ADDENDUM TO THE OPERATION MANUALS FOR

**90-350 PROFORM AND MAXFORM
HYDRAULIC PRESS BRAKES**

**POWEREXPRESS[™]
HYDRAULIC DIE CLAMPING**

Addendum to EM-506 & EM-537

FIGURE 4- Safety Tongues

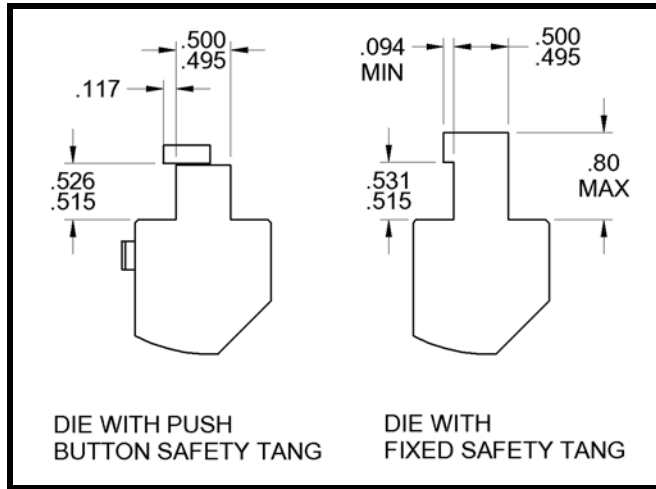
SAFETY TONGUE: The upper dies can include a safety style tongue that stops the die from falling out of the upper clamping when the upper clamping is released. With the PowerExpress™ hydraulic clamping, the proper safety tongue geometry is required for safe operation and the self seating feature to function properly. The following illustrates the proper safety tongue geometry.

WILSON TOOL INTERNATIONAL UPPER DIES WITH THE PUSH BUTTON SAFETY TANG MANUFACTURED BEFORE 2008 MAY NOT CONFORM TO THESE DIMENSIONS. IF THEY DO NOT COMPLY, CONTACT WILSON TOOL INTERNATIONAL (1-800-445-4518) FOR UPDATED BUTTON KITS. DO NOT USE DIES UNTIL UPDATED.

FIGURE 4- Eccentric Load

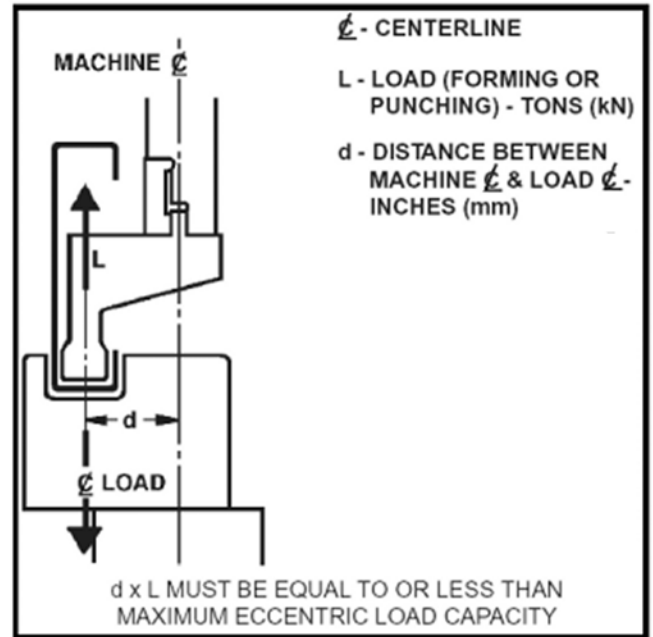
Occasionally special forming setups are made which do not have their load centers located on the bed and ram centerlines. See "Eccentric Load" figure that follows. When this condition exists, care must be taken not to exceed the maximum eccentric (front-to-back) load capacity of the machine. See "Eccentric Loading Capacity" figure on the next page. The slope of the line is 0.66 inch-Tons/inch (5.88 kN-mm/mm).

EXCEEDING THE ECCENTRIC LOAD CAPACITY COULD OVERSTRESS BED, DIE CLAMP, AND RAM NOSE ATTACHMENT BOLTS CAUSING THEM TO SHATTER AND POSSIBLY CAUSE SERIOUS INJURY TO PERSONNEL. DAMAGE COULD ALSO OCCUR TO THE SLIDES AND GUIDES AND SINK UPPER BED BOLTS INTO THEIR COUNTERBORES, CAUSING THE BED OR GUIDING CONNECTIONS TO LOOSEN.

FIGURE 5 - Minimum Area

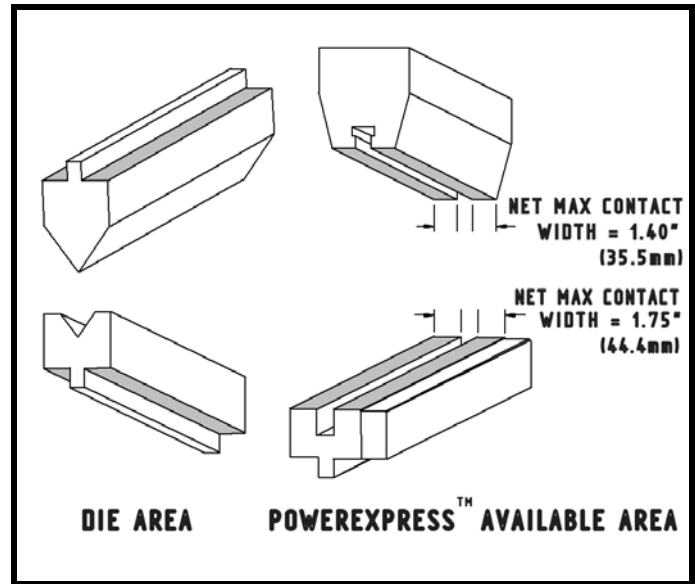
Replace the last paragraph of the **IMPORTANT** note under step 20 with:

Revise the figure under the **IMPORTANT** note below step 20 to the following:

An example for a 350 ton (3114kN) machine, the minimum lower die area for a capacity load is 350 divided by 15, or 23.3 square inches (15030 sq. mm). Minimum upper die area is 11.7 square inches (7520 sq. mm). If PowerExpress™ option is added, and upper die is thicker than 1.94" (49.3mm), minimum length of die at maximum tonnage is 8.33" (212mm).
